NOTICE TO ALL CONTRACTORS AND SUB-CONTRACTORS

CKMHC – Children Services, Building Renovation – JGR Proj #24-3459

ADDENDUM NO. 3

Sheet A7.1

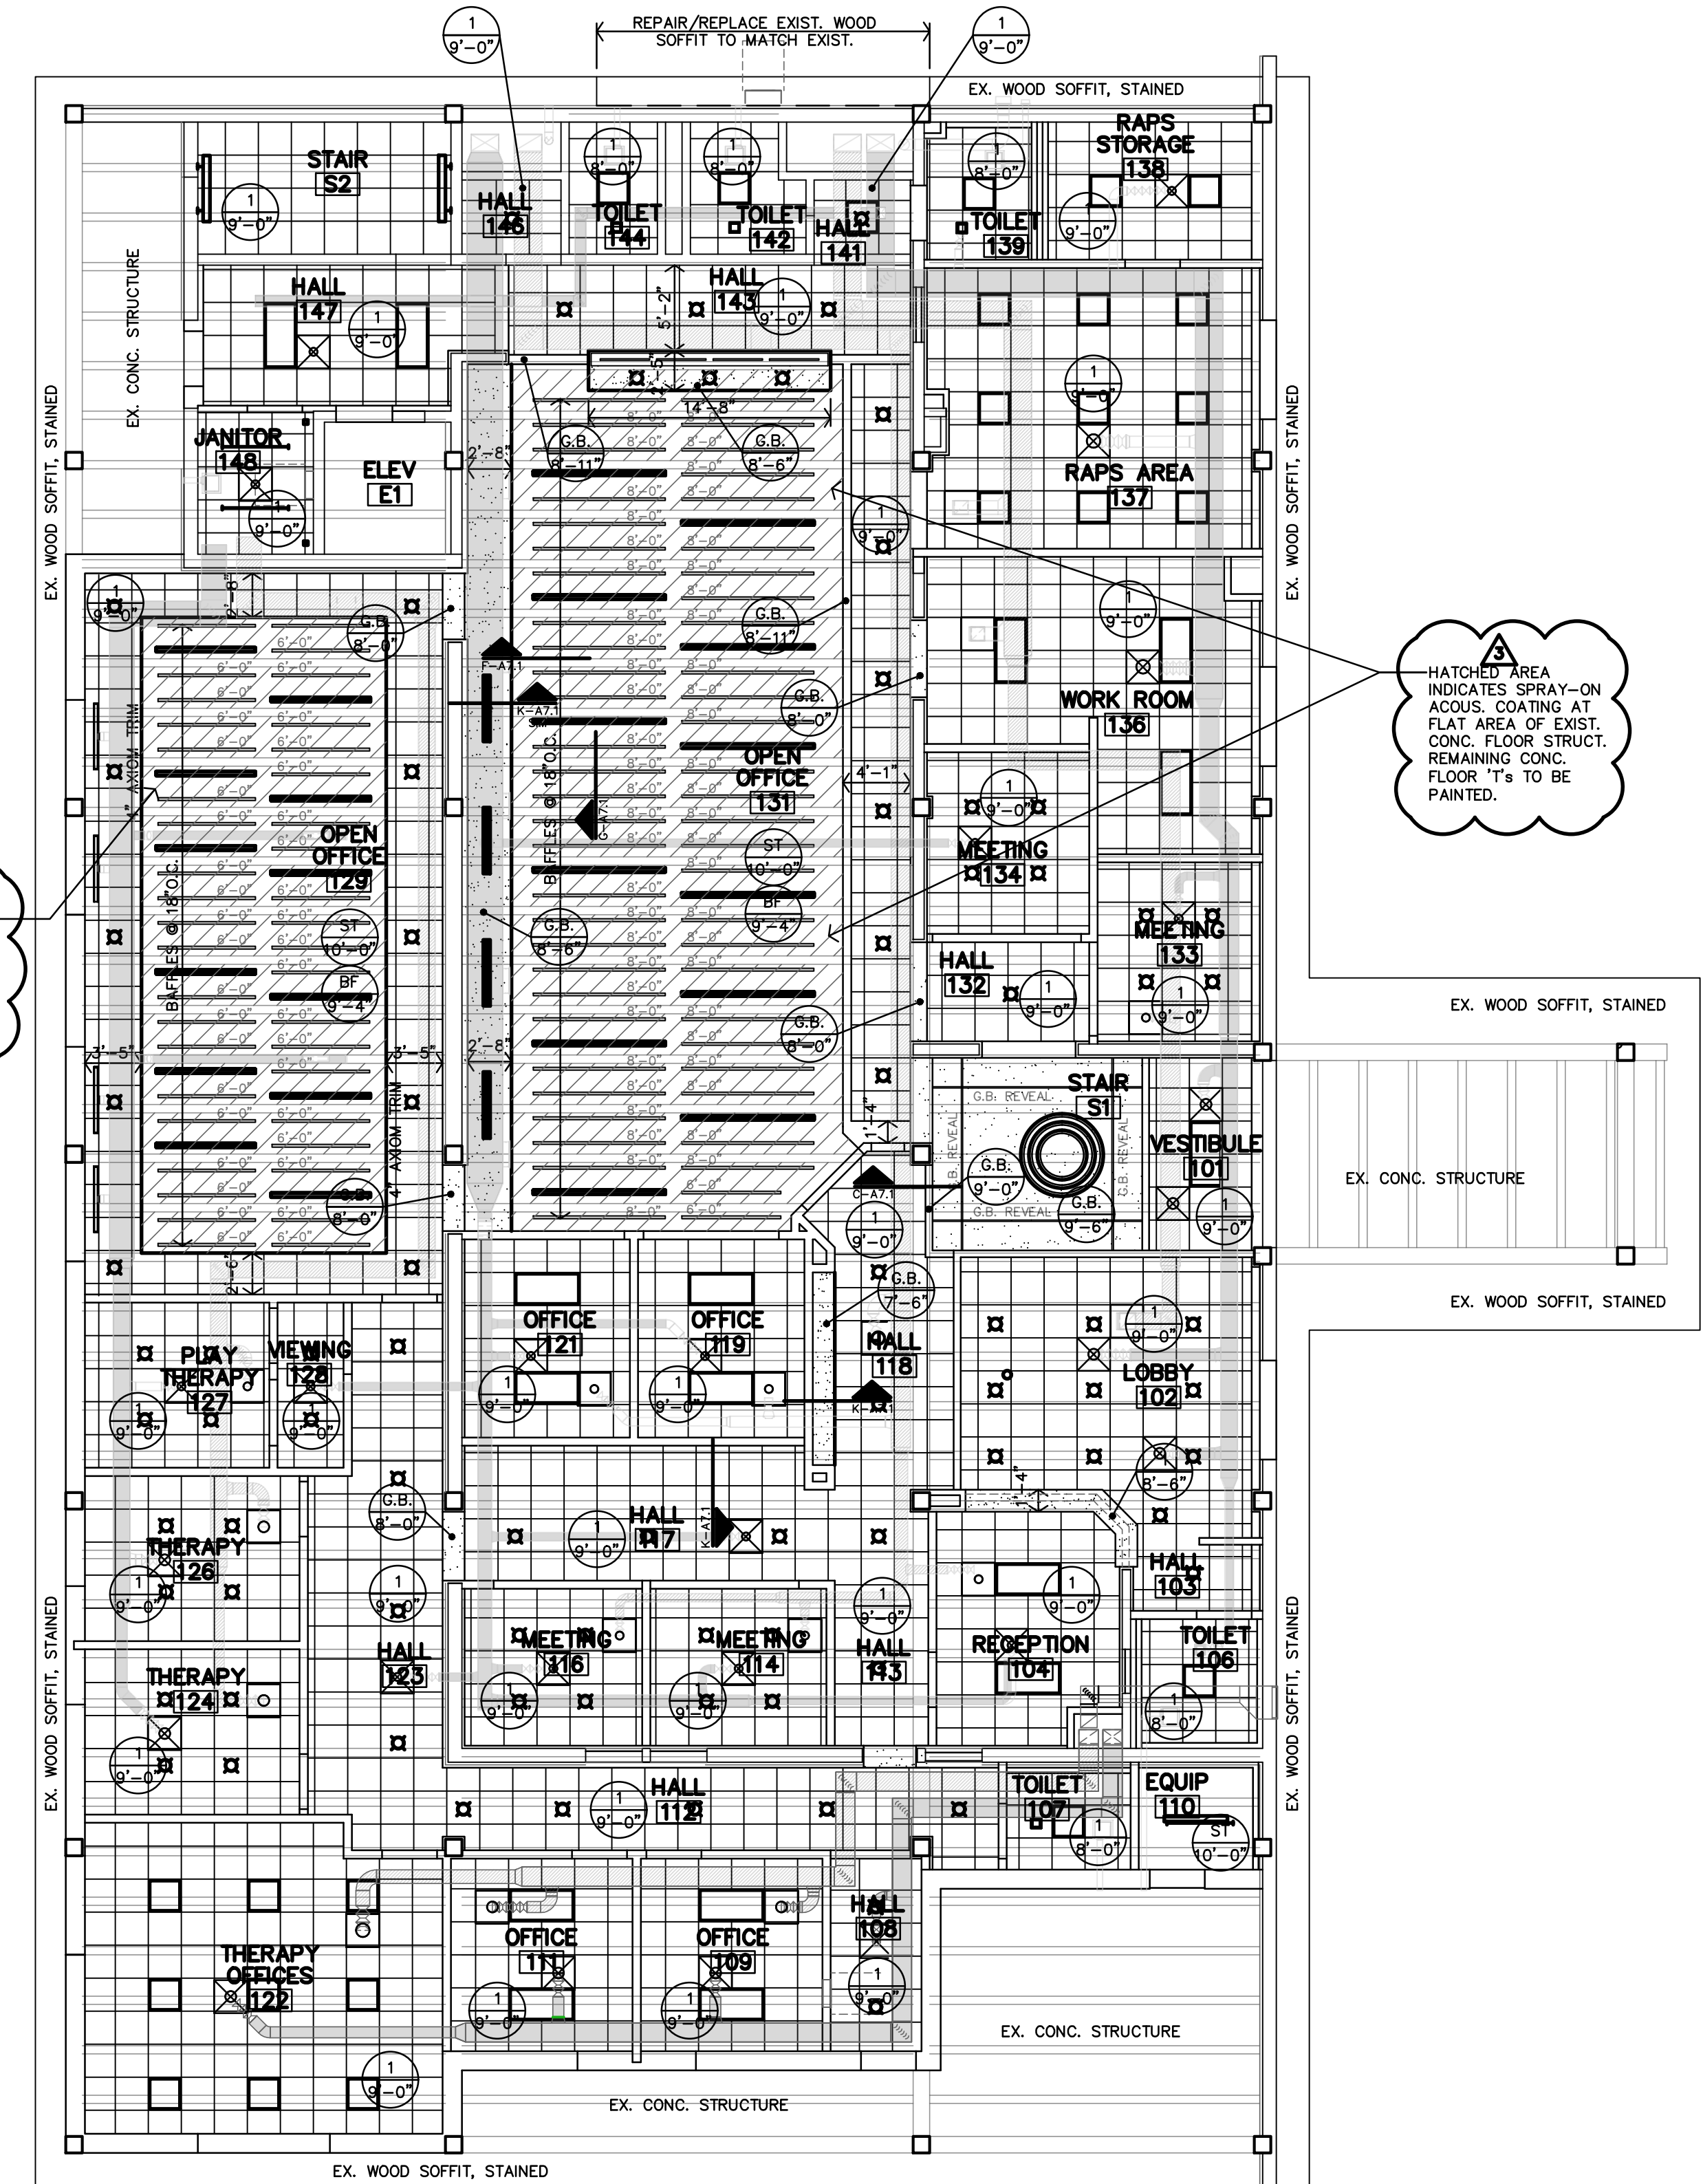
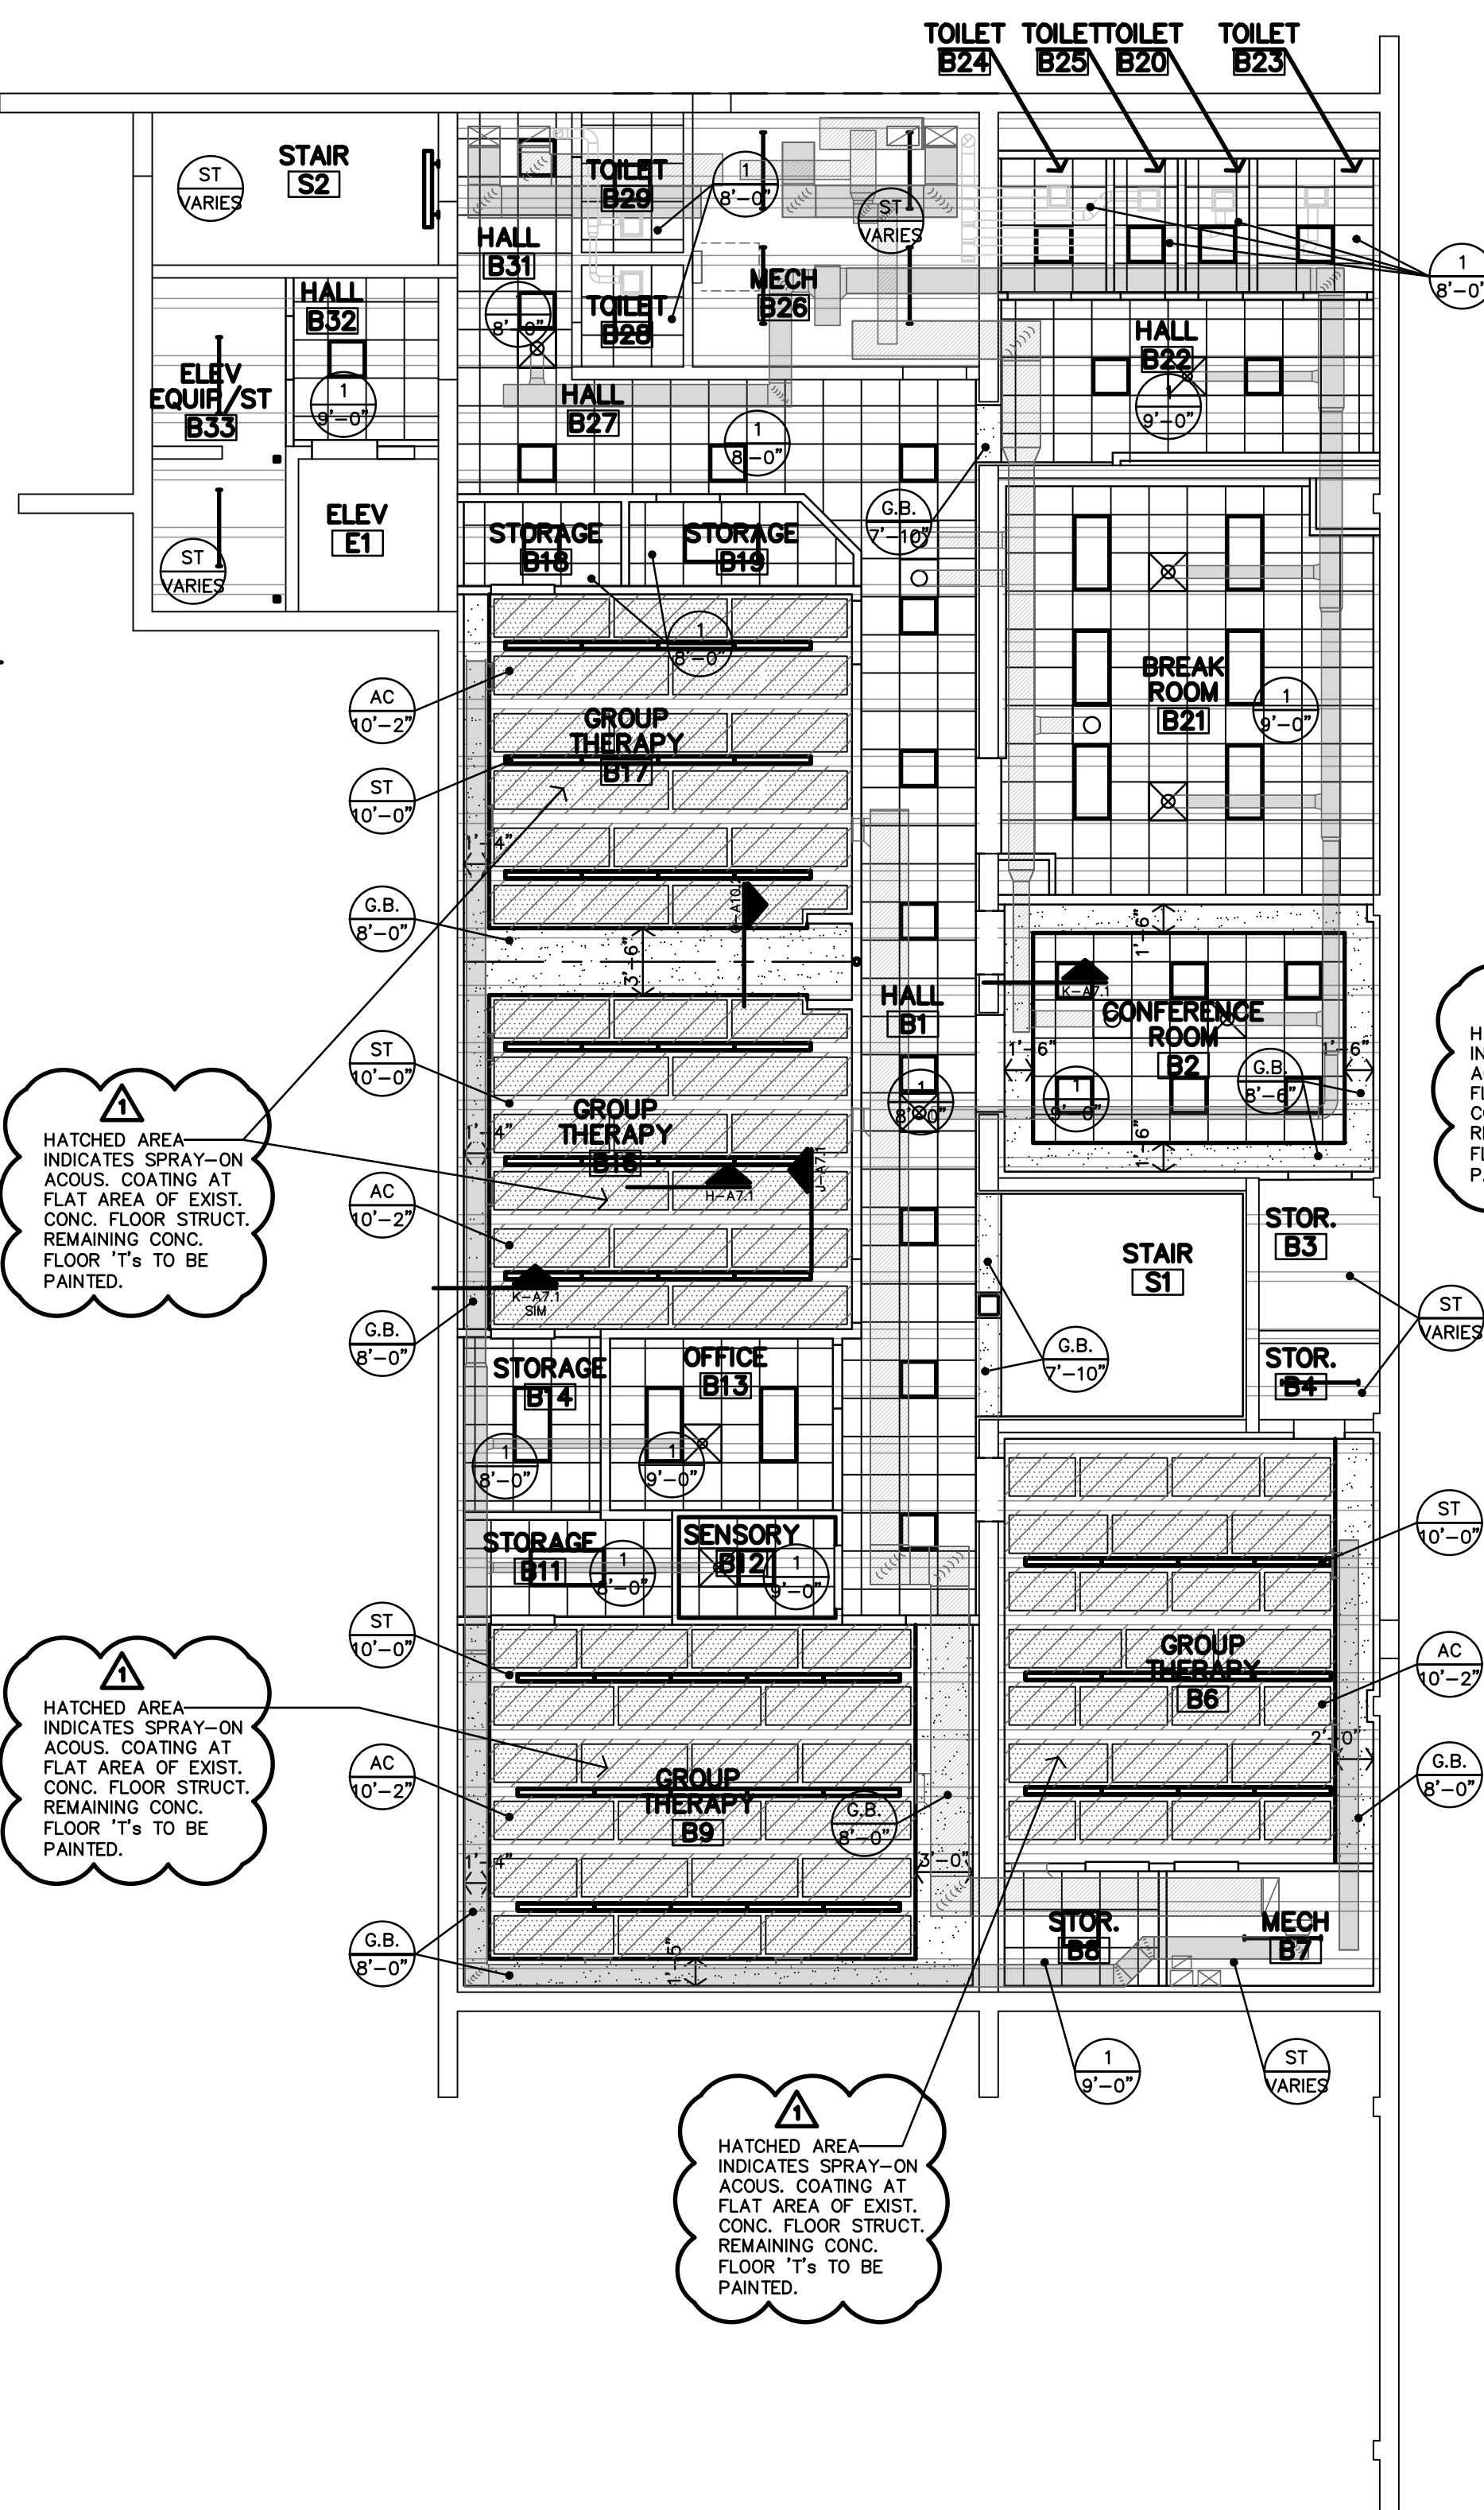
1. Sheet A7.1 Ceiling Plans – Replace this sheet with the revised Sheet A7.1 included with this addendum. Spray-on Acoustic Finish material shall be installed above all open and semi-open ceilings. This includes Open Office 129, Open Office 131, and Group Therapy Rooms B6, B9, B16, and B17. All spray-on material shall be 2" thick to provide a NRC rating of 100.

3. Sheet A7.1 Reflected Ceiling Plan Notes – Sprinkler piping clarification:
 1. All sprinkler piping shall be designed and routed to minimize visibility of the piping. At open ceiling areas with suspended baffles, piping shall be located as high as practicable and in no case shall the piping be located below or through the baffles. All sprinkler piping shall be painted to match the ceiling color at exposed areas.

2. Sprinkler systems shall be designed to meet the requirements of NFPA 13. At open ceiling and baffle areas, Open Office Areas 129 and 131, any deviations to NFPA 13 requirements shall only be allowed with the approval of the City of Salina Building Official and the City of Salina Fire Marshall.

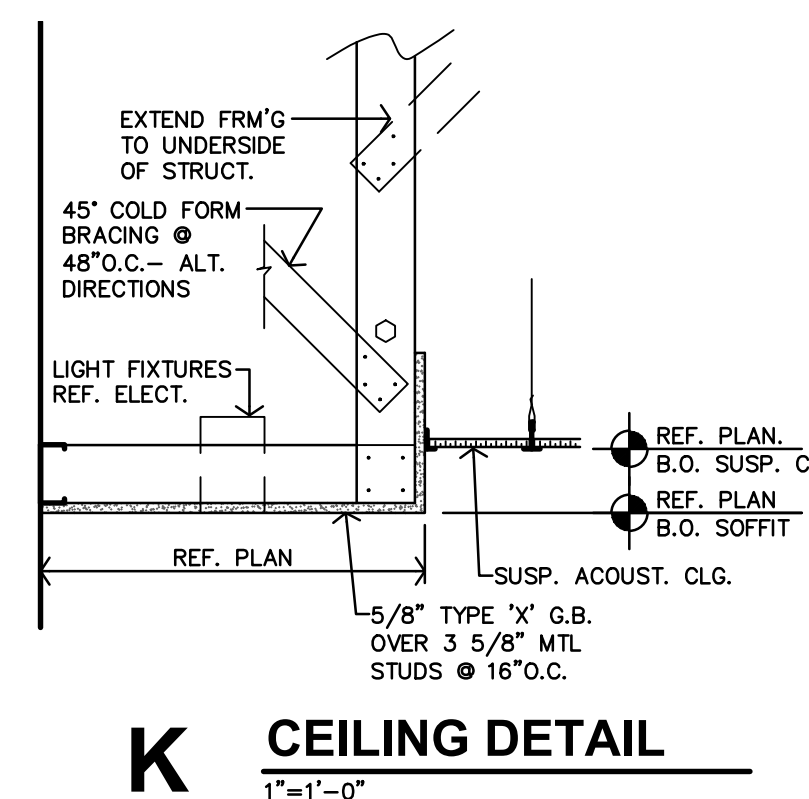
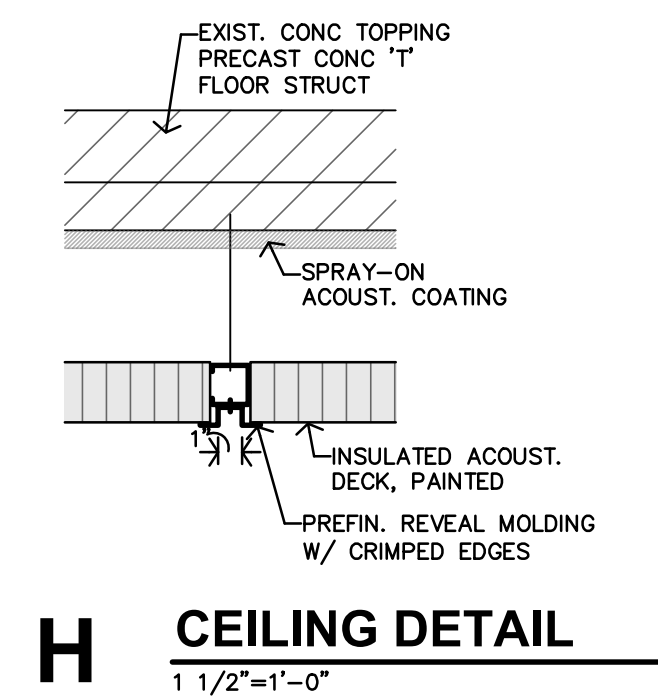
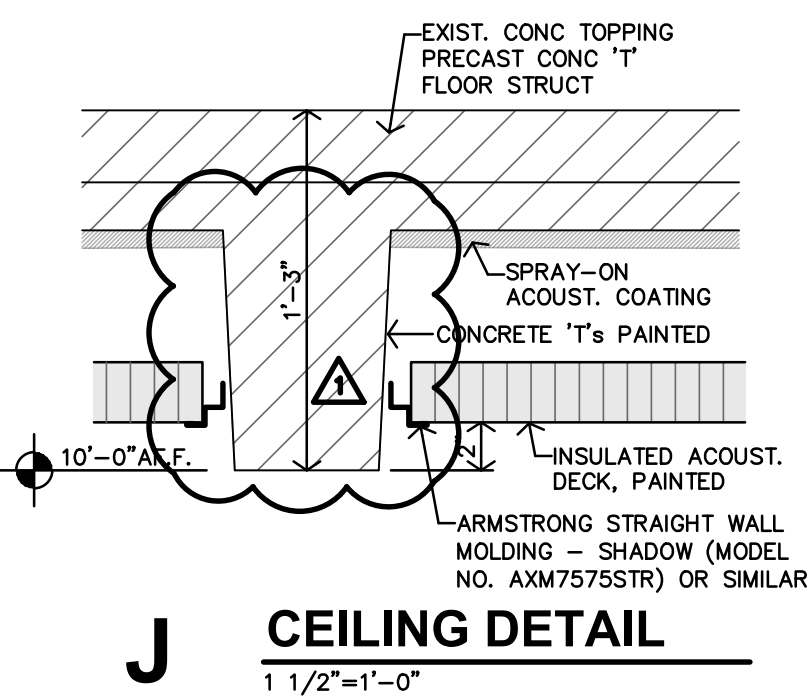
2. Sheet A7.1. Ceiling Details – At Group Therapy Rooms B6, B9, B16, and B17, The suspended steel deck ceiling panels are to be equivalent to Epic Metals, Toris A, steel deck with integral insulation. Total thickness of deck to be 2.5". 20ga material with perforated face. Exposed surfaces to be painted.
